Service Notice

DO NOT BLOCK Decal

FIGURE #1

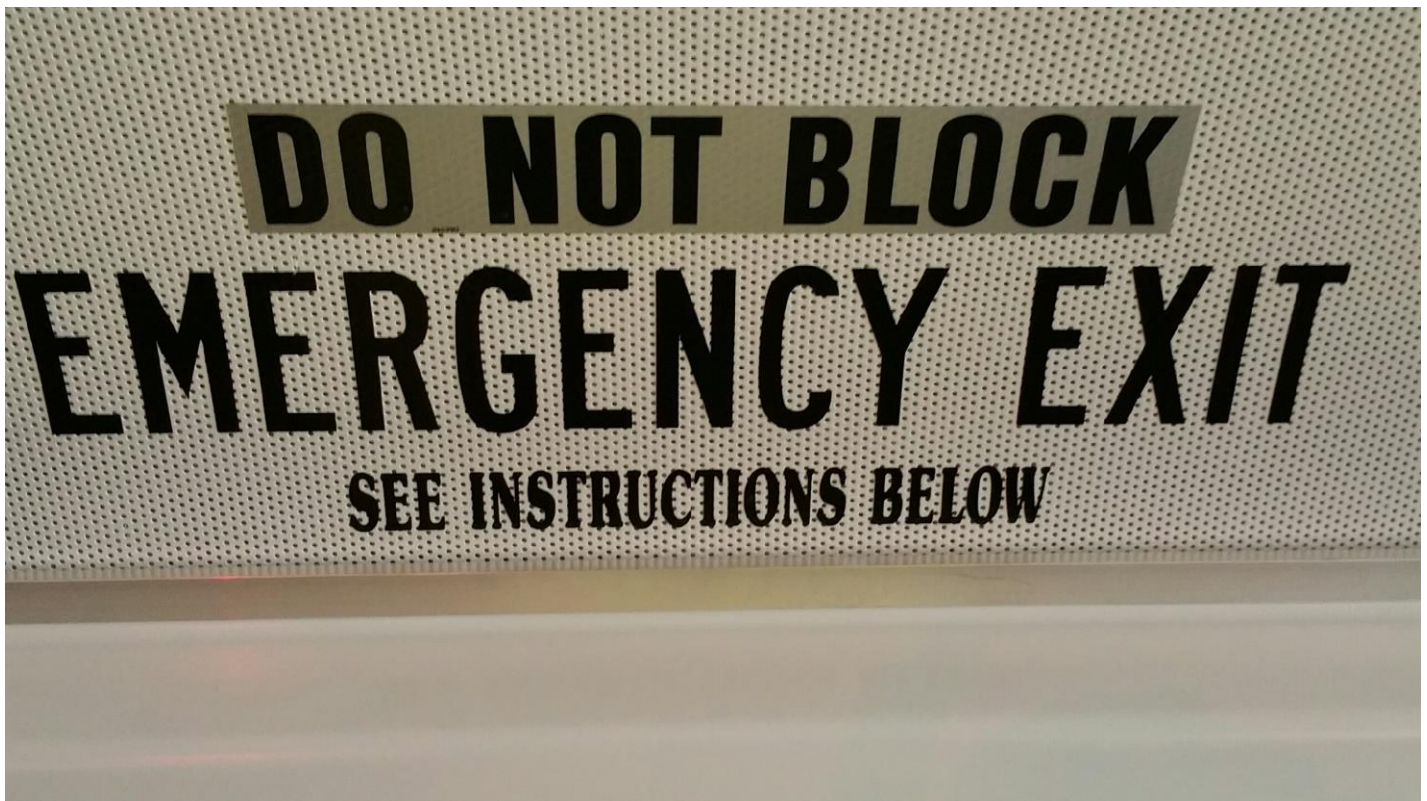
Blue Bird has done an audit of FMVSS requirements and found that the “DO NOT BLOCK” decal which was previously installed on ALL vehicles over the “EMERGENCY EXIT” decal (FIGURE #1) is not required is vehicles w/o wheel chairs. Therefore with this year’s units on a fully seated bus you will no longer see the decal at the emergency exits.
